TAC-SER05-001 Rev B
03-11-05

**Subject: Mount Kit for 2004-05 Ford E-Series w/6.0L Diesel
(Part #72-62035-00,01,02)**

74-62028-00, RETROFIT KIT, 2004-05 FORD E-SERIES 6.0L MAX MOUNT WELDMENT CAMPAIGN

Carrier A United Technologies Company Carrier Transicold Division 50 Grumbacher rd York PA. 17402 USA	Drawing No. 98-62686	Rev. B
	Date Jan 12, 2005	Sheet 2 of 6
Title: INSTALL INSTR, SUPPL 04 FORD 6.0L 74-62028-00	Supersedes	Date Sheet of

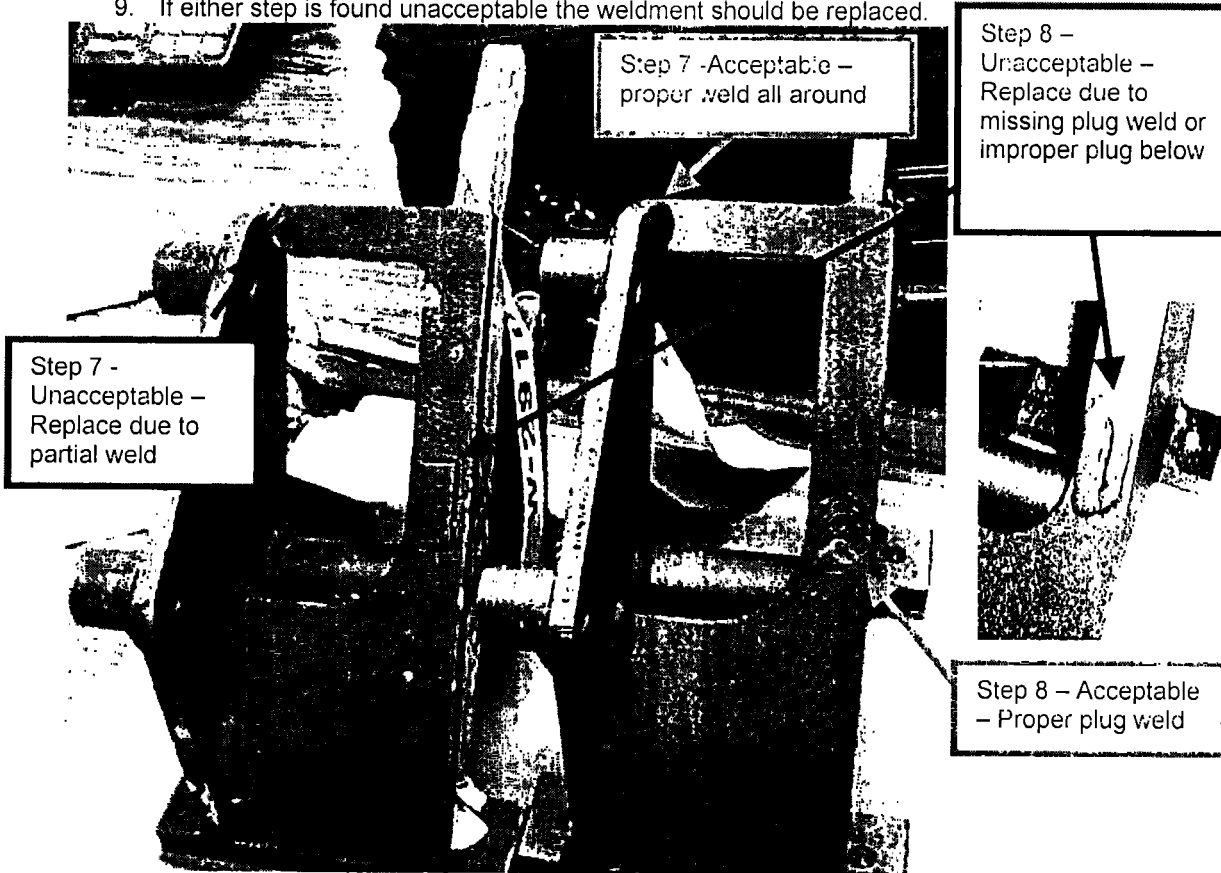
7. Inspect the weld in the areas indicated below.
8. Inspect the area illustrated below for a plug weld at the tab.
9. If either step is found unacceptable the weldment should be replaced.

10. Fill out supplied label (62-62047-00) and adhere to the underside of vehicle hood so it is readily visible when hood is opened.
 - a. If weldment is found to be acceptable then no further action is required and the label should be completed and say "Pass" and "Not Required". Complete label (follow examples below) and adhere cover.

Carrier A United Technologies Company Carrier Transicold Division 50 Grumbacher rd York PA. 17402 USA	Drawing No. 98-62686		Rev. B
	Date Jan 12, 2005	Sheet 2 of 6	
Title: INSTALL INSTR, SUPPL 04 FORD 6.0L 74-62028-00	Supersedes	Date	
		Sheet of

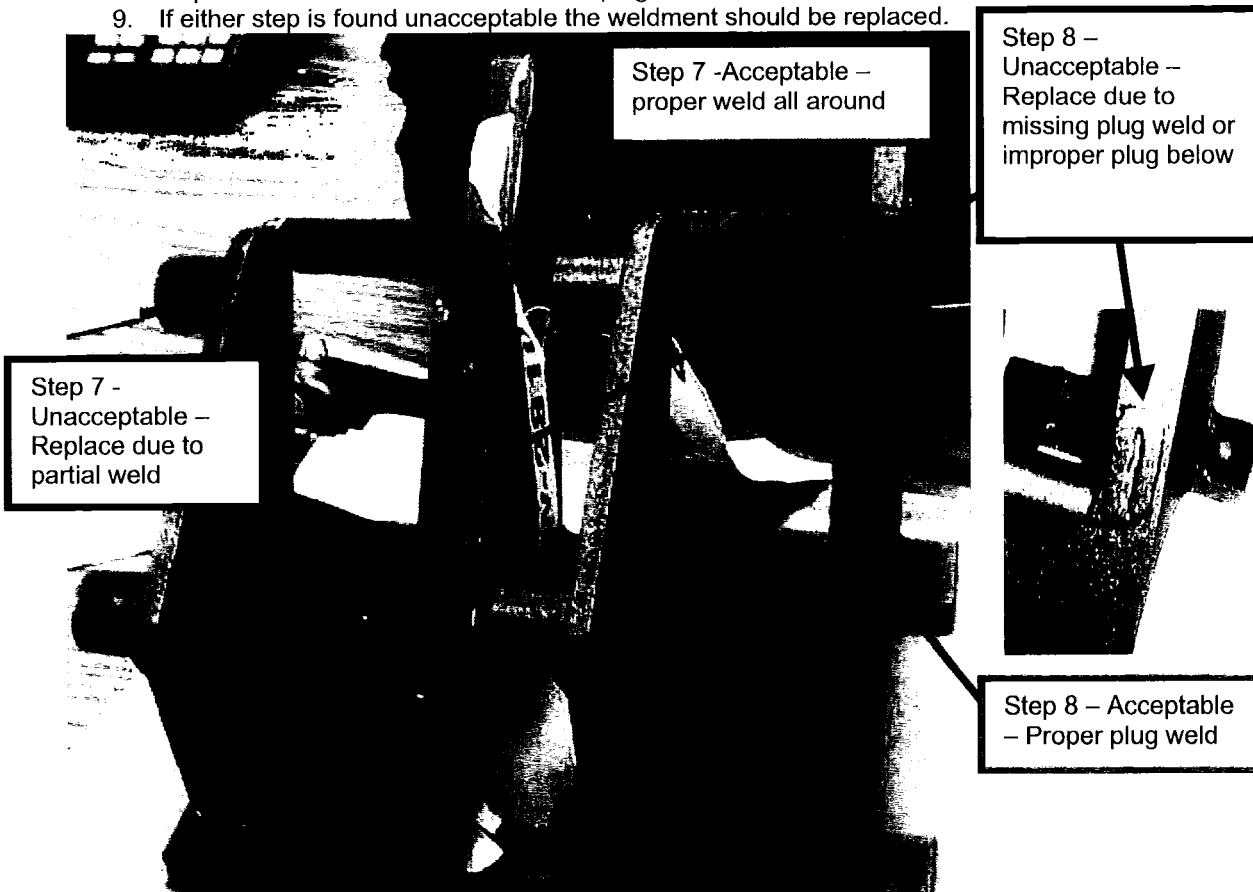
7. Inspect the weld in the areas indicated below.
8. Inspect the area illustrated below for a plug weld at the tab.
9. If either step is found unacceptable the weldment should be replaced.

10. Fill out supplied label (62-62047-00) and adhere to the underside of vehicle hood so it is readily visible when hood is opened.
 - a. If weldment is found to be acceptable then no further action is required and the label should be completed and say "Pass" and "Not Required". Complete label (follow examples below) and adhere cover.
